# City of Mississauga Department Comments

File(s): A153.24 Ward: 5

The applicant requests the Committee to approve a minor variance to permit 25 parking spaces whereas By-law 0225-2007, as amended, requires a minimum of 46 parking spaces in this instance.

Property Address: 2447 Anson Drive, Unit 2

### Appendix 1 – Transportation and Works Comments

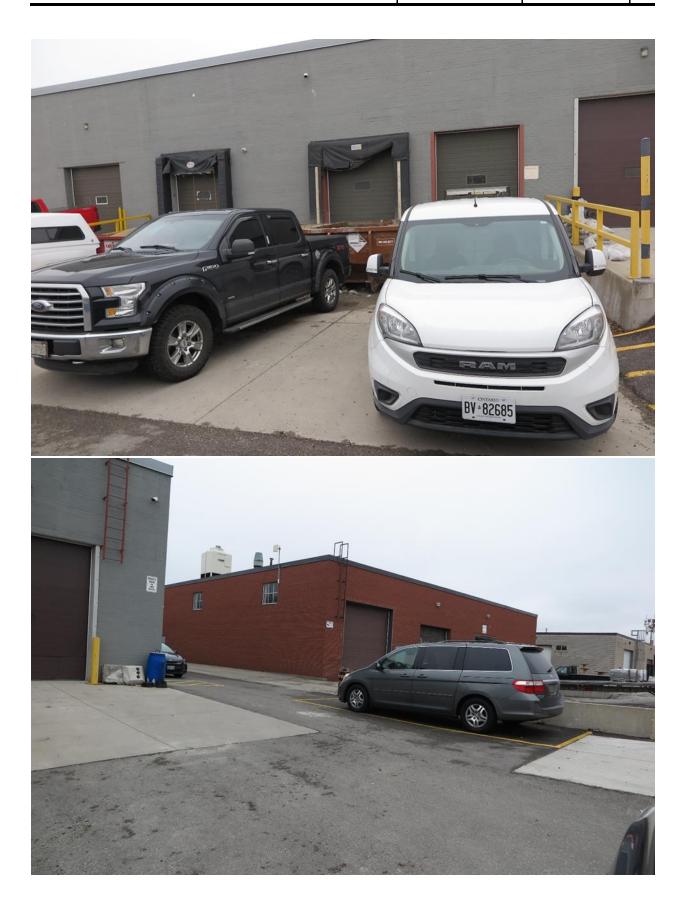
Enclosed for Committees easy reference are photos depicting the subject property. We note from our site inspection of the property and as depicted on the enclosed photos that vehicles are currently parked within the delineated parking spaces along Unit #1 (2447 Anson Drive) which is depicted as an existing driveway. We also note that the Site Plan DWG A1 submitted depicts parking spaces at the rear of the buildings which are questionable as this area is currently a truck loading area.
